# ALTERATION TO A HISTORIC PROPERTY STAFF REPORT

Site: 1 Westwood Road c.1929 Somerville Museum

Case: HPC 2012.019 R1 Westwood Road Local Historic District

Legal Notice: Addition of short fence for ADA chair lift

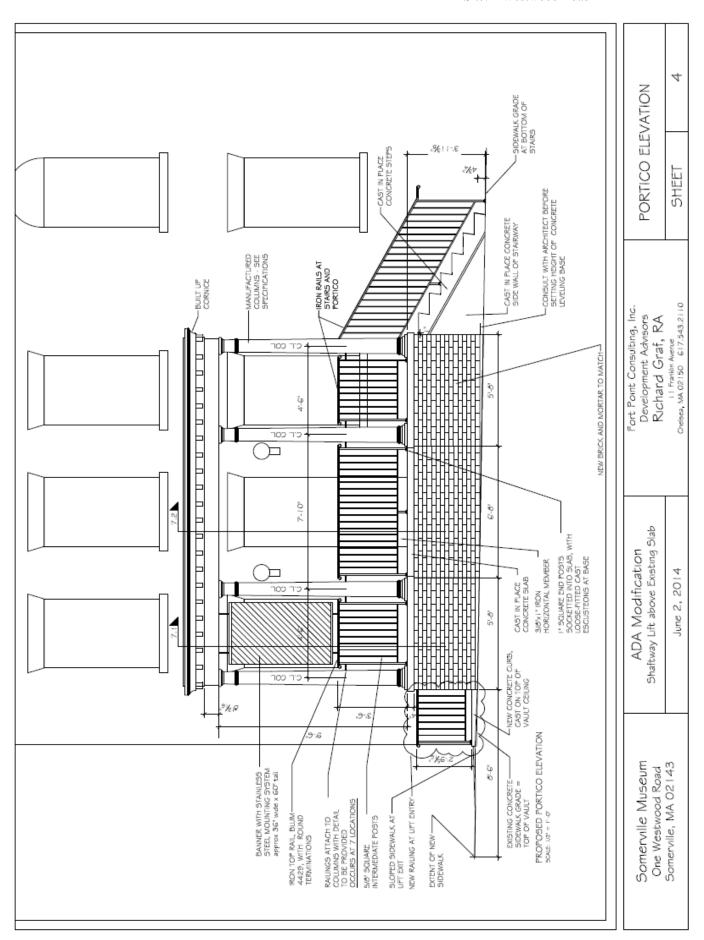
1. A short railing shall be installed per plans Sheets 3 and 4 by Richard Graf, Fort Point Consulting Inc., dated January 21, 2014 at the intersection of the ramp to the chairlift and the public sidewalk.
